# FIRE SAFETY INSPECTION REPORT

**Factory Name: Besta Apparels (New)**

**ACCORD ID: 23264**

**Date: 06 June, 2018.**

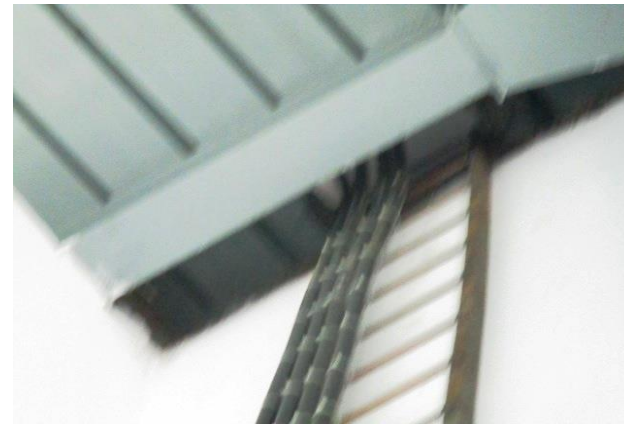
2	Fire Rated Construction	Liquefied or compressed gas cylinders were located within the factory under the east exit stair.	The storage or use of liquefied or compressed flammable gas cylinders shall be prohibited within the factory building.	Within 3 months
---	-------------------------	--	--	-----------------

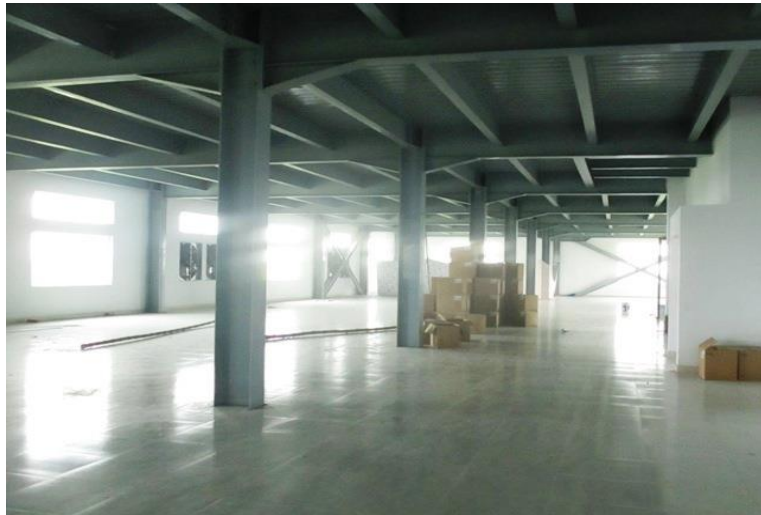
8	Egress	Width of aisles is less than 0.9m (36-in.) or not marked properly at several floors .	Aisles shall be provided with a minimum unobstructed clear-width of 0.9 m (36 in.).	Immediate
---	--------	---	---	-----------
